Item ID: D412-664-203

Item Name: Crosstube Aft

DRAWING NO. D412-664-243	TITLE CROSSTUBE ASSEMBLY (412 HI AFT)	REV. E	DART AEROSPACE LTD ENGINEERING ORDER		D.E.O. NO. D412-664-243-E-1	SHEET NO. SHEET 1 OF 2	SCALE NTS
DRAWN	CHECKED <i>MP</i>	MFG. APPR. <i>E</i>	APPROVED <i>MP</i>		DE APPR. <i>H</i>		
DATE 11.03.31	DATE 11/03/31	DATE 11.03.31	DATE 11/03/31		DATE 11.03.31

**D412-664-243
ASSEMBLY DETAIL**

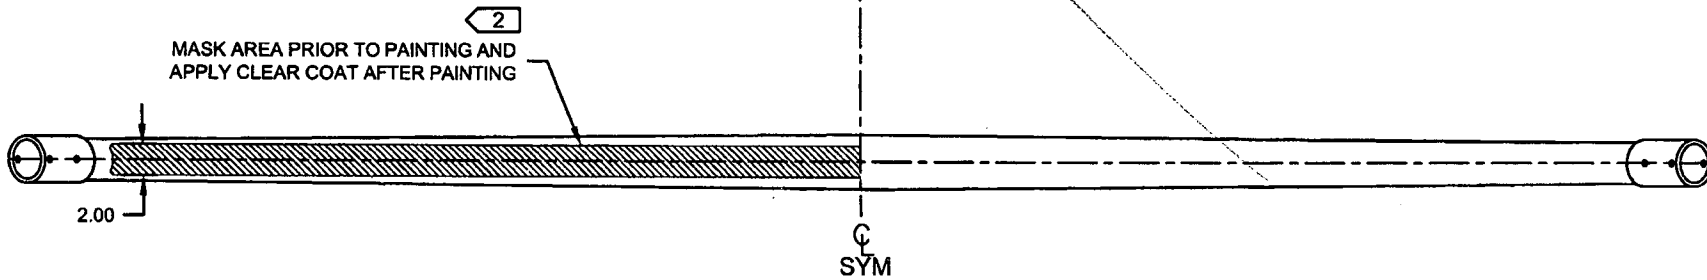
WAS:

D2856-600-1009 ABRASION STRIP
D3189-1 CHAFING SHIELD (1, INSTALLED OVER ABRASION STRIP)
MS21920-28 CLAMP, 2X
2 PL

**D412-664-243
ASSEMBLY DETAIL**

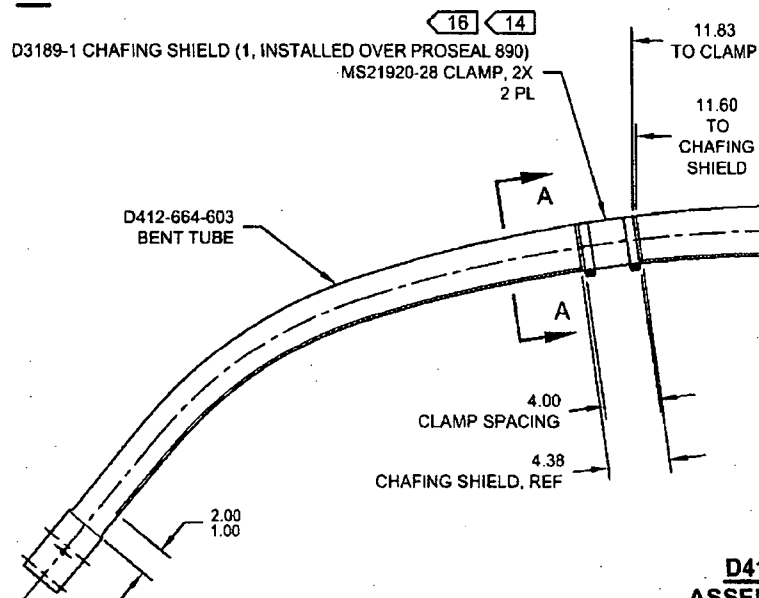
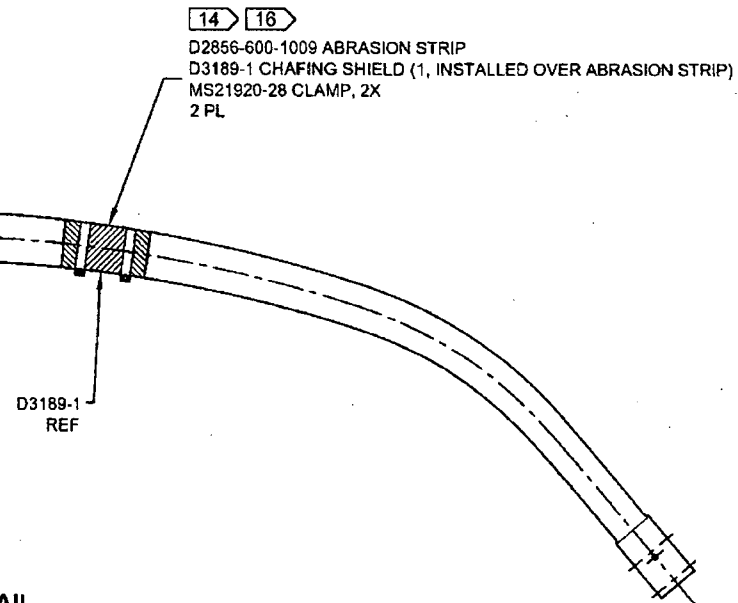
IS:

WAS:

CRUSHING OF D412-664-243

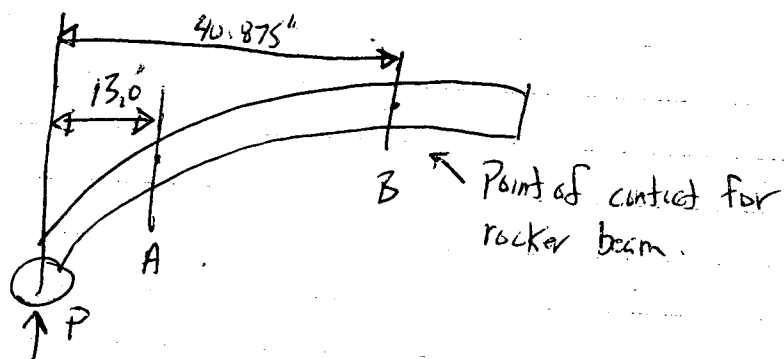
Acceptability of 8% CRUSHING AT END OF BEND

Point A: $OD_1 = 2.961"$, $OD_2 = 2.522"$
